REMARKS

IN THE DRAWINGS

Replacement and annotated drawing sheets showing changes to Figs. 1A-1C, 3, 4, 5 and 7 are included as attachments.

FIG. 1A (PRIOR ART)

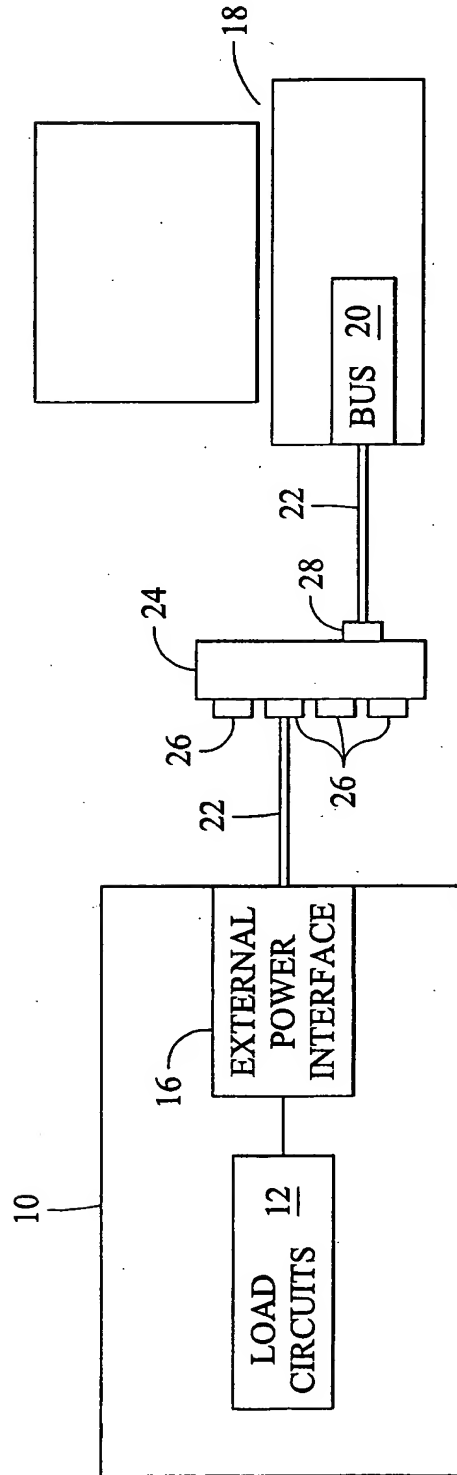
Figs. 1A-1C are revised to include the legend "Prior Art".

FIG. 1C (PRIOR ART)

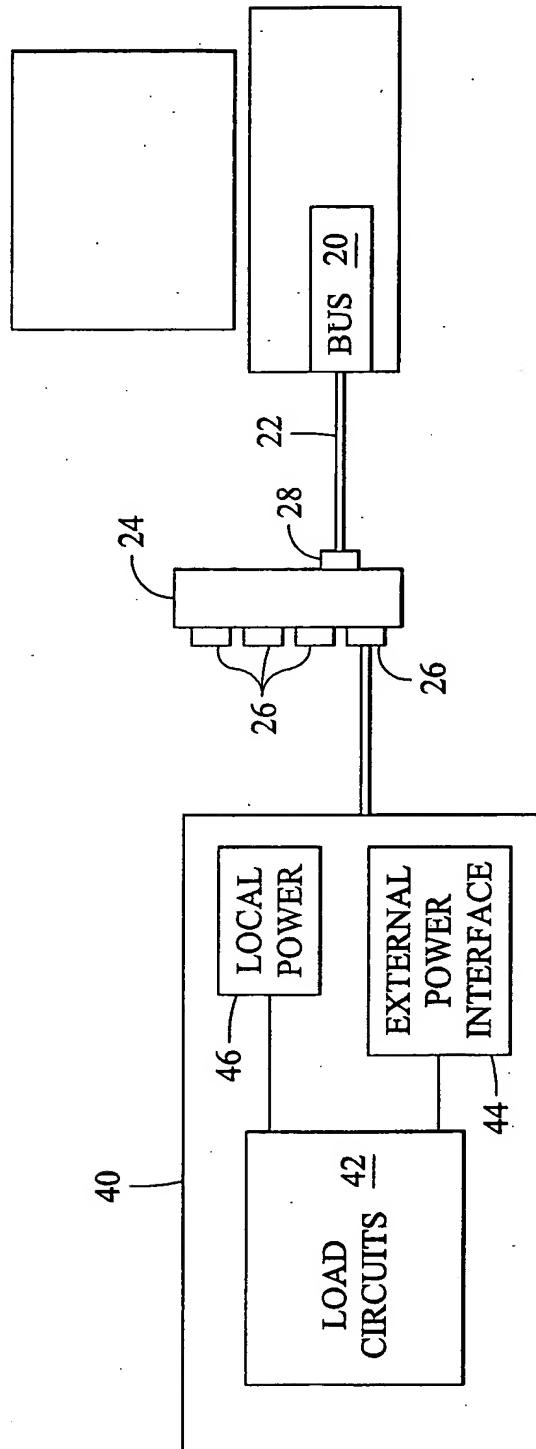
Fig. 1C is revised to include reference designator 18.

FIG. 3

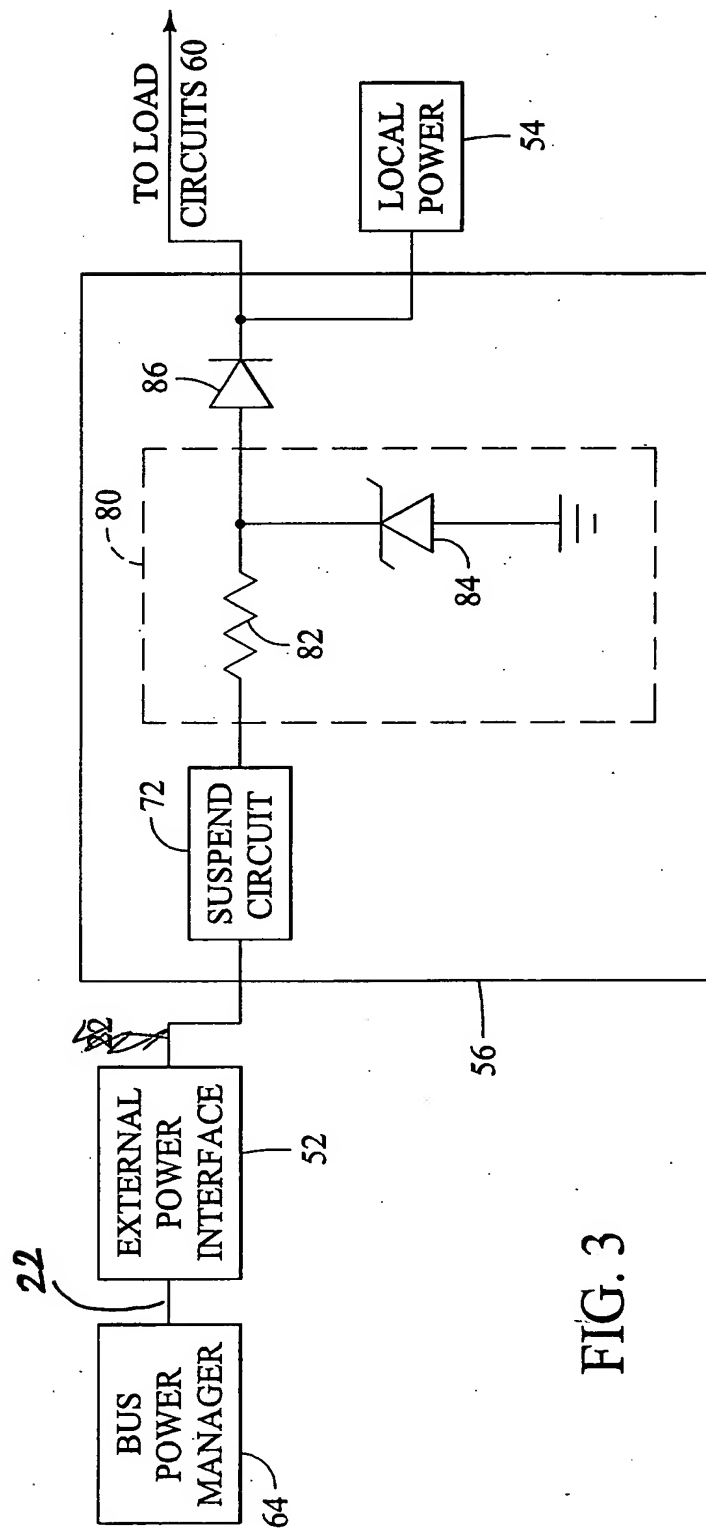
Fig. 3 is corrected to change the location of reference designator 22.

FIG. 4

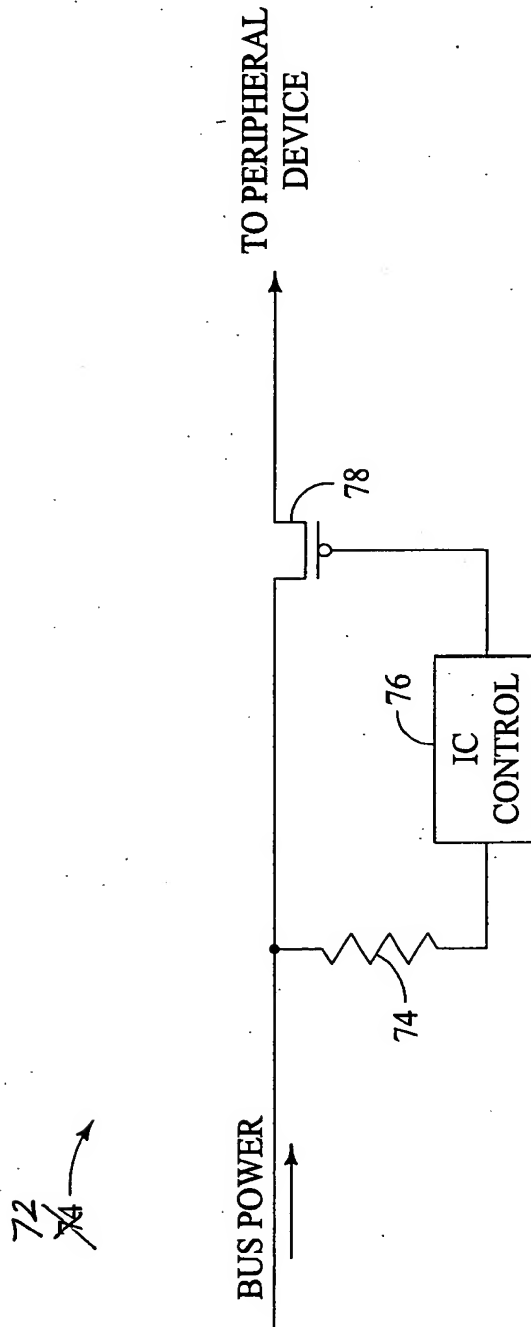
Figs. 4 and 7 are corrected to change the reference designator for the suspend circuit from 74 to 72.

FIG. 5

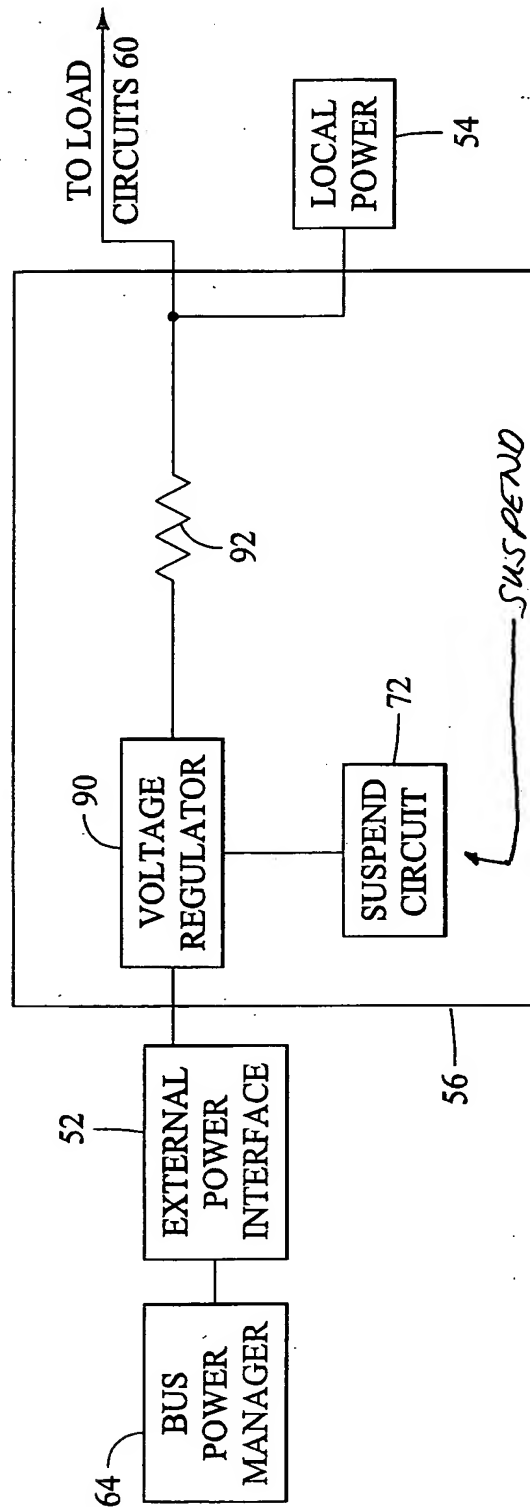
Figs. 5 and 7 are revised to show an input signal to the suspend circuit. Support for this revision can be found throughout the specification, for example, at page 6, lines 15-18.
